SUBJECT: OLD CASTLE ROAD PIPELINE PH. 2 PROJECT
[PROJECT NO. 01-06-78-51420]
ADDENDUM NO. 1

ADDENDUM NO. 1
TO CONTRACT DOCUMENTS AND SPECIFICATIONS
FOR CONSTRUCTION OF THE
OLD CASTLE ROAD PIPELINE PH. 2 PROJECT
[PROJECT NO. 01-06-78-51420]

VALLEY CENTER MUNICIPAL WATER DISTRICT
VALLEY CENTER, CALIFORNIA

OLD CASTLE ROAD PIPELINE- PH 2
PLAN AND PROFILE
100+00.00 TO 110+00.00

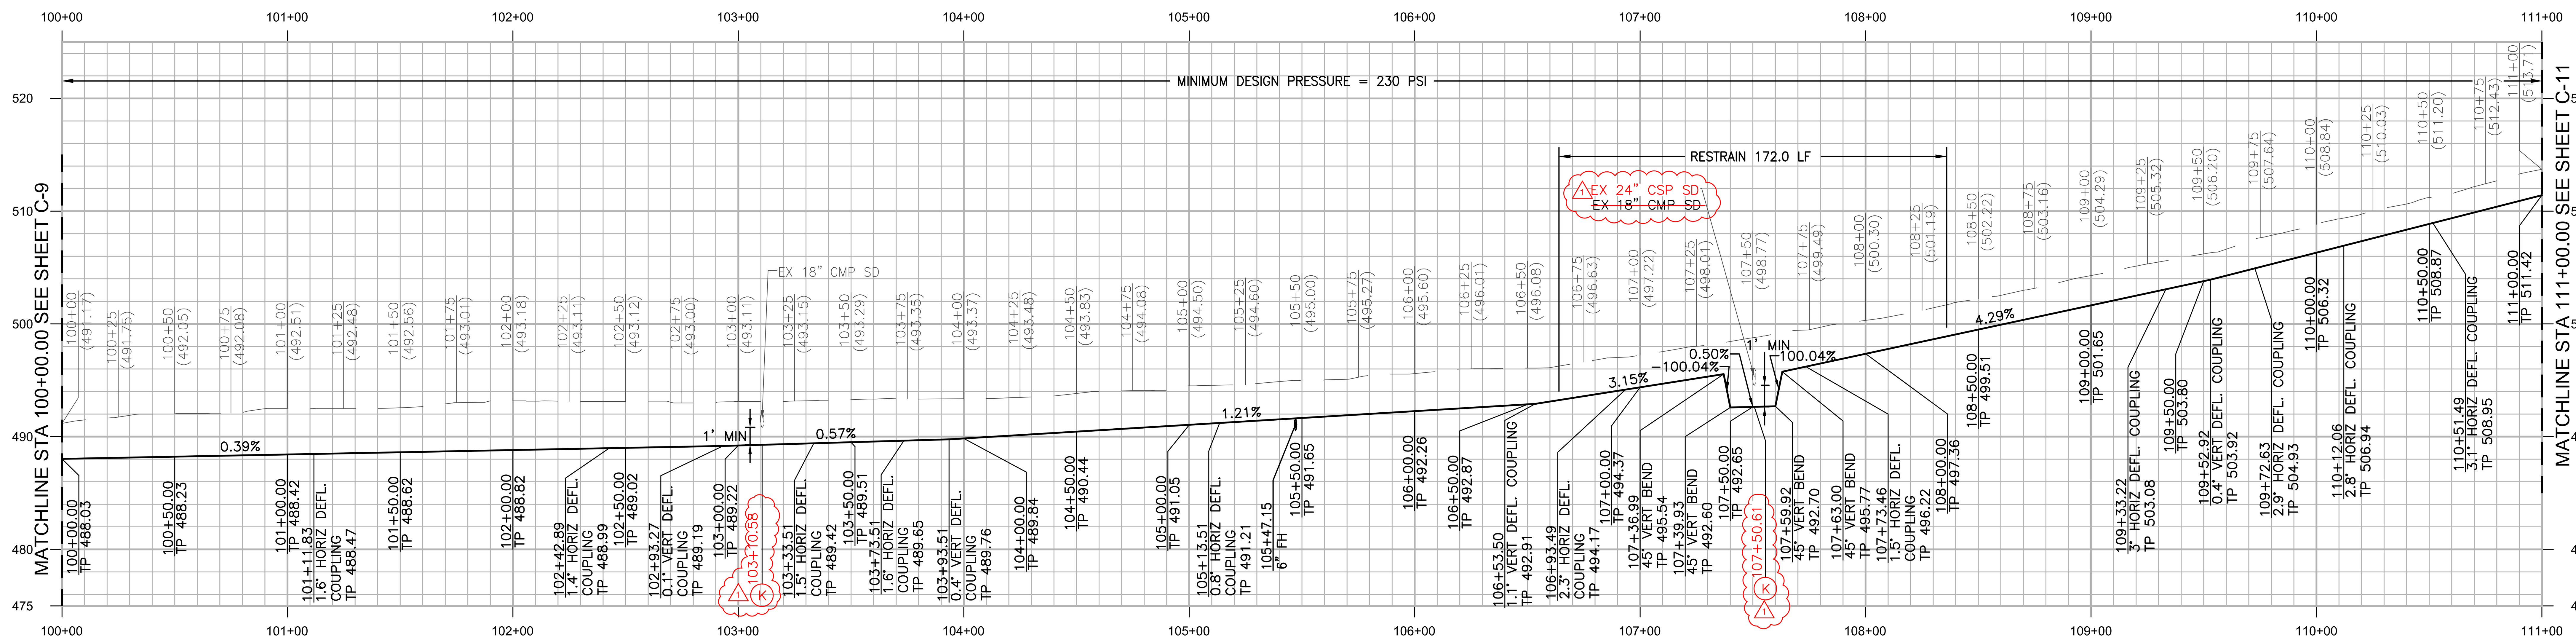
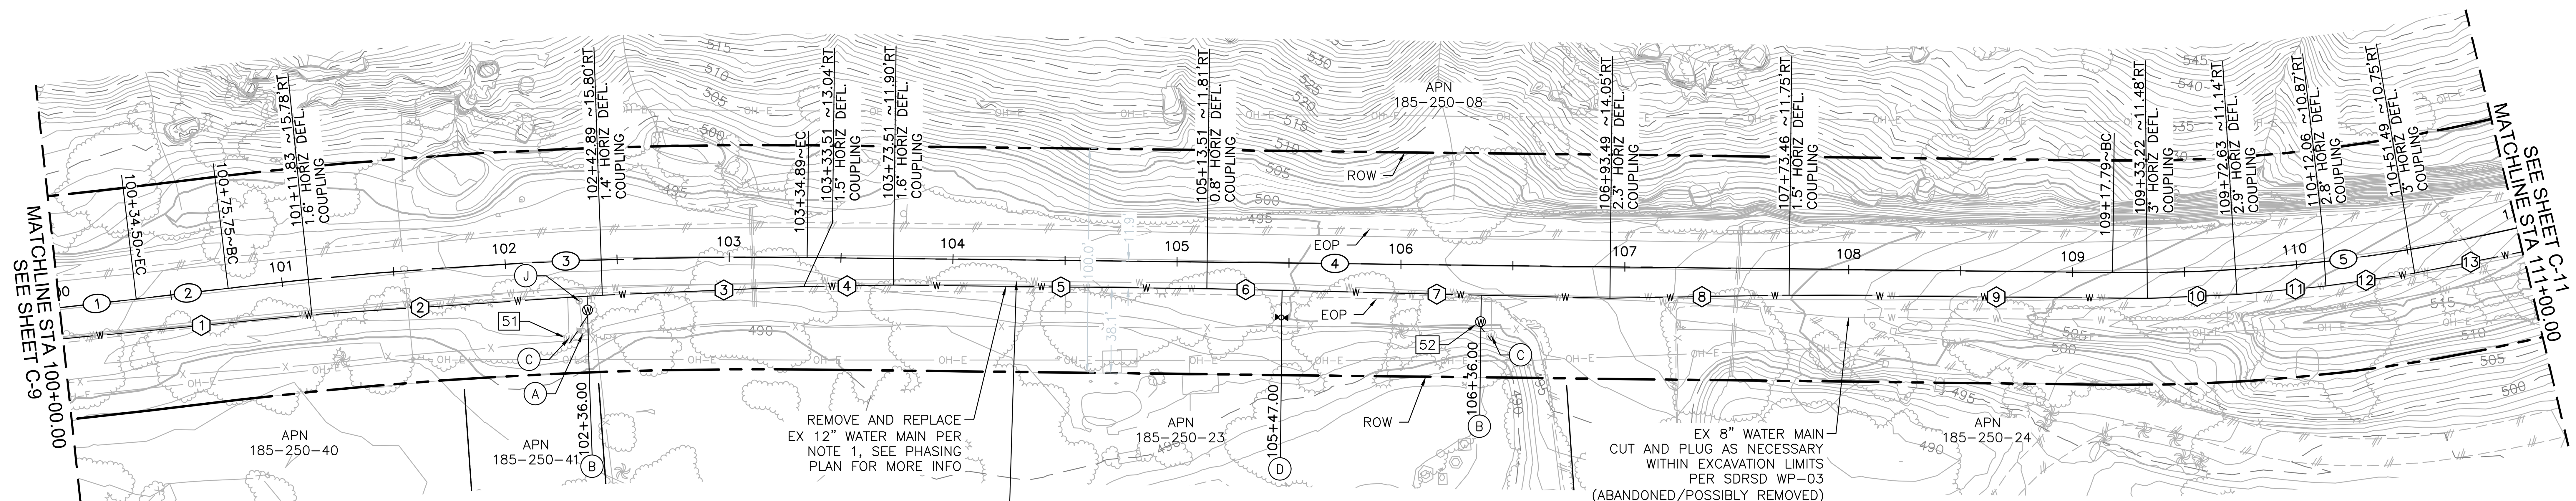
Item No. 11 - Sheet 13 of 34 (C-10)

- Requires a full 20-foot stick of C900 centered at the storm drain crossing.
- Sta 107+50: Updates storm drain diameter.

OLD CASTLE ROAD PIPELINE- PH 2
PLAN AND PROFILE
110+00.00 TO 120+00.00

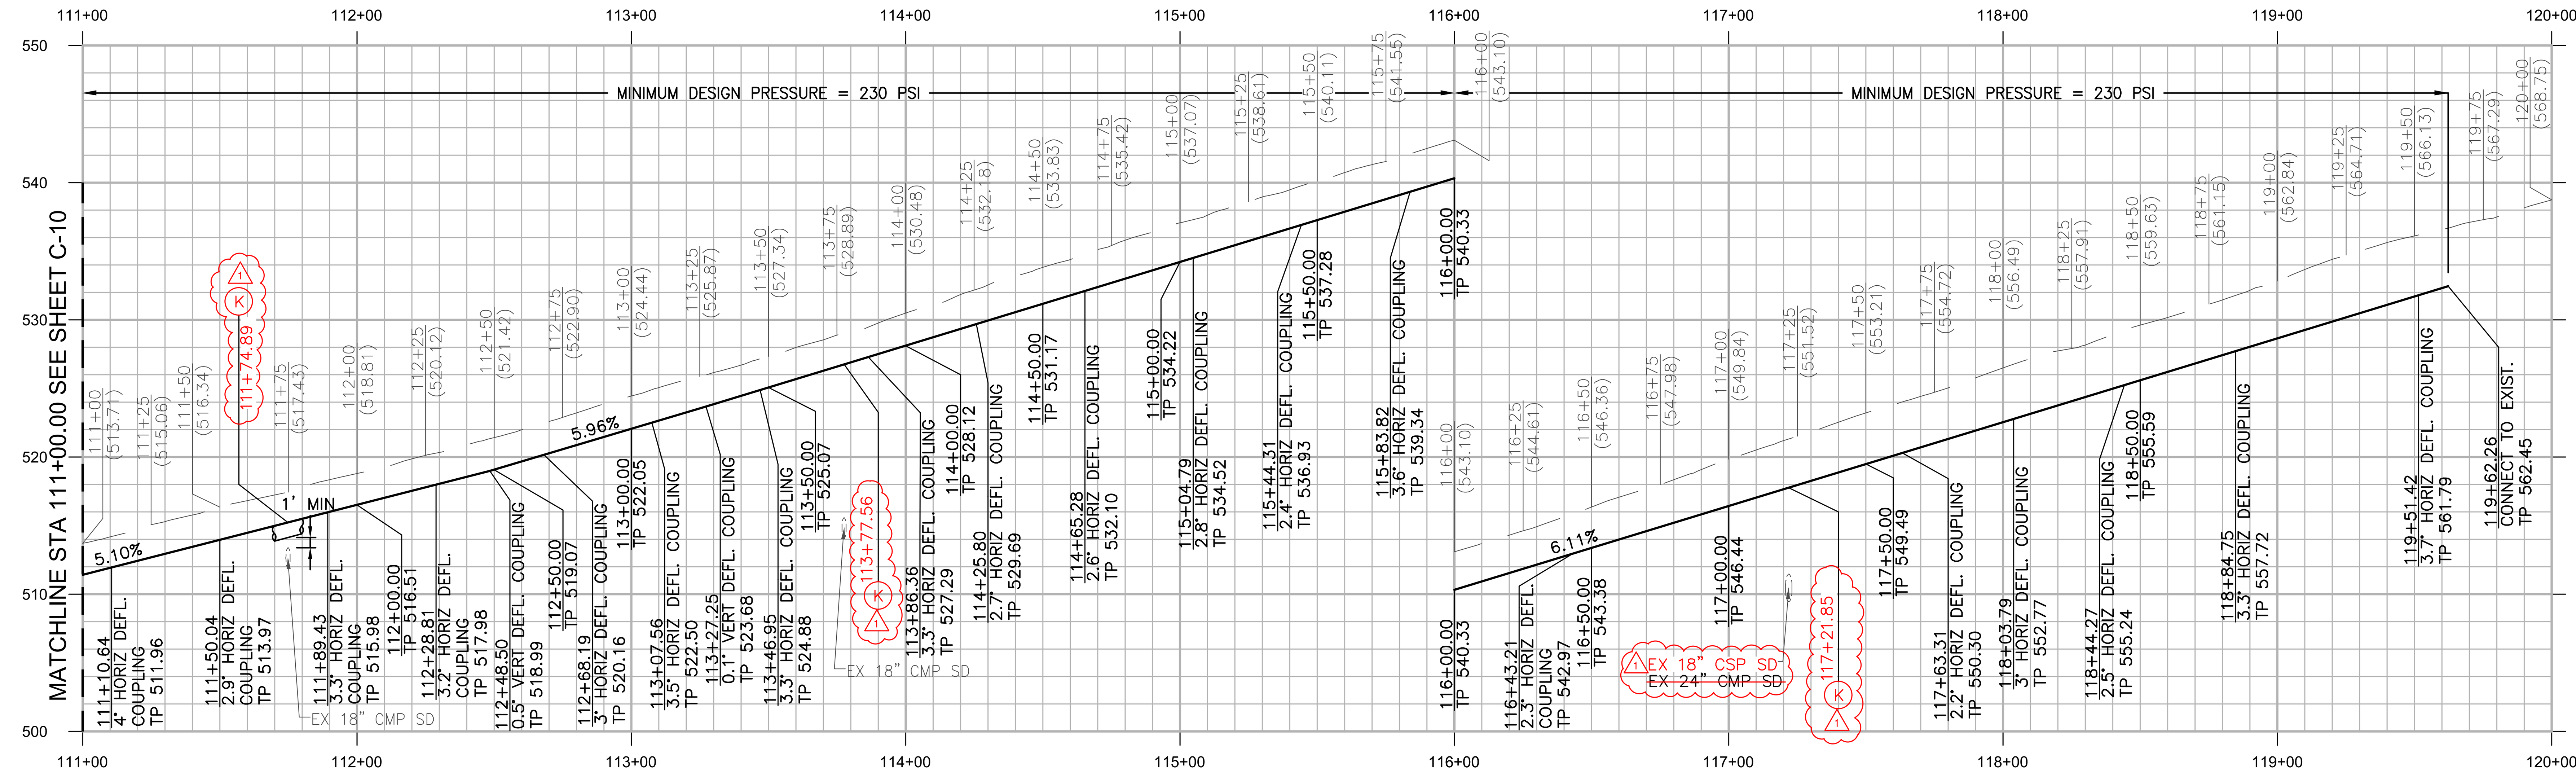
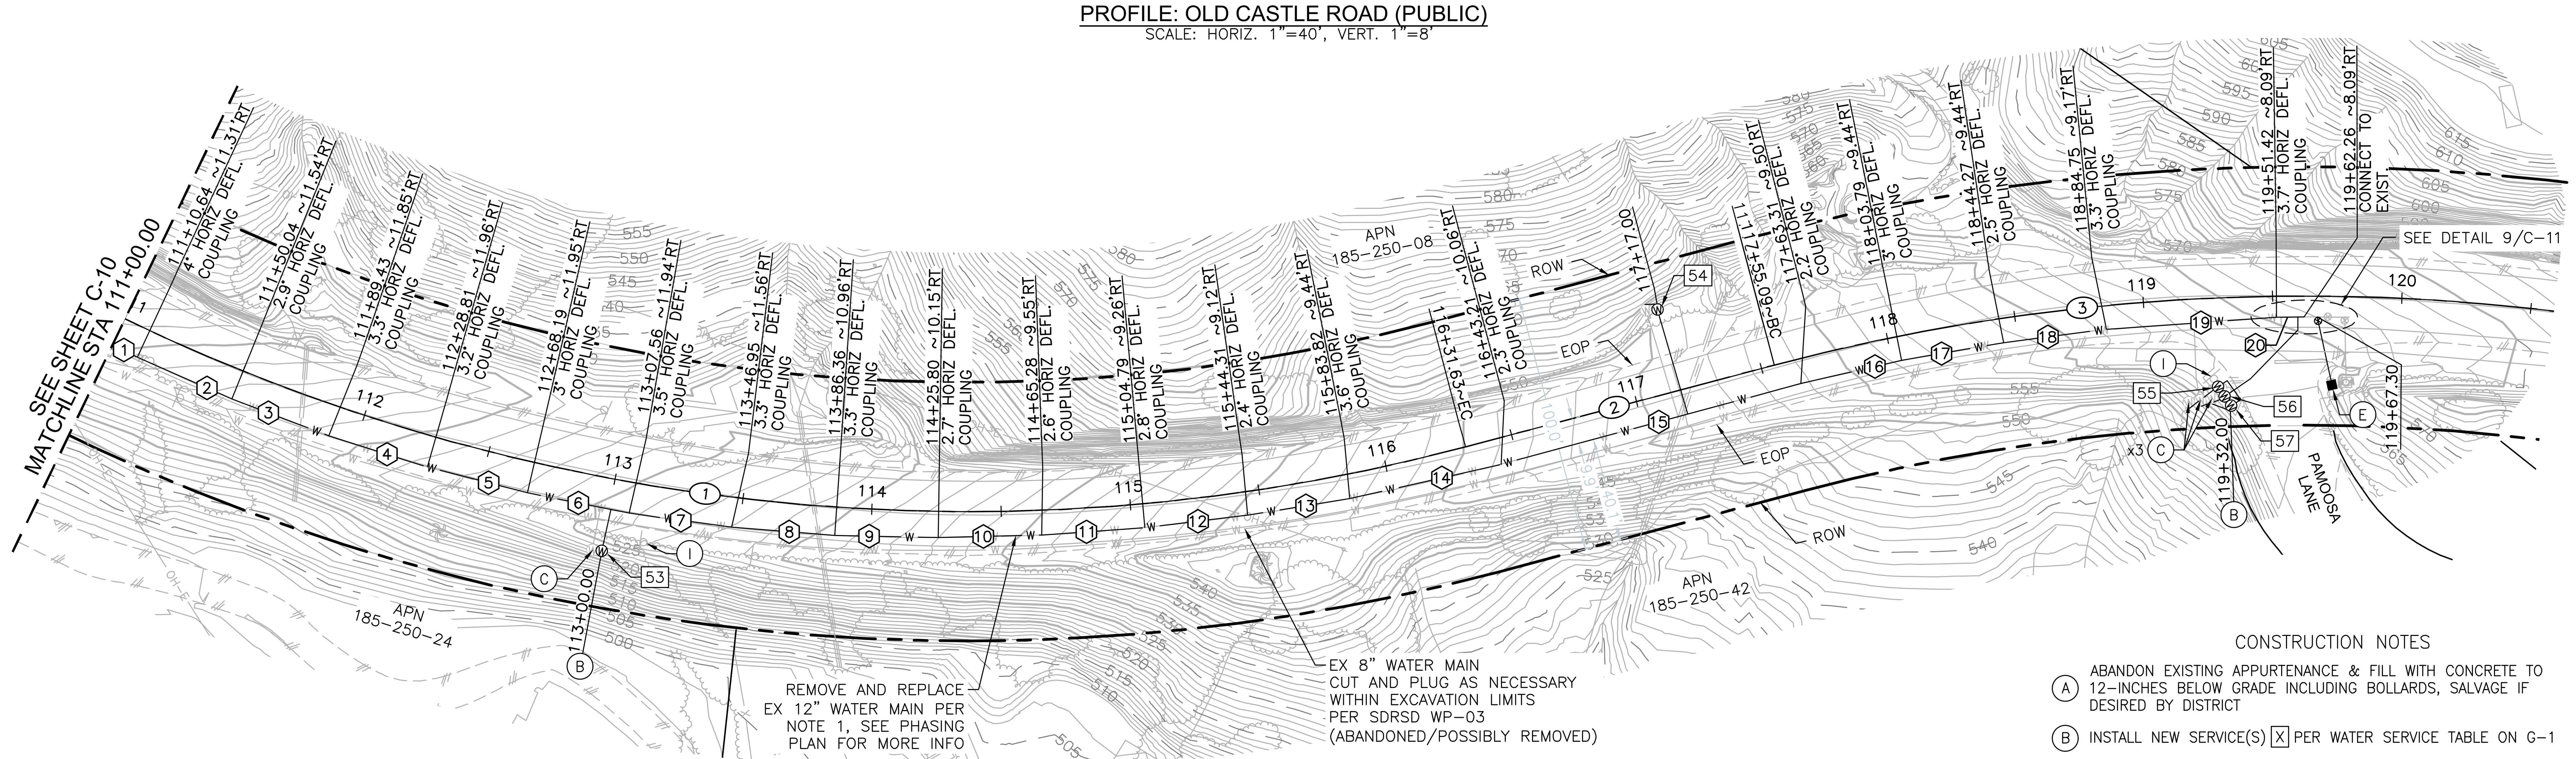
Item No. 12 - Sheet 14 of 34 (C-11)

- Sta 117+20: Updates storm drain diameter.
- Requires a full 20-foot stick of C900 centered at the storm drain crossing.
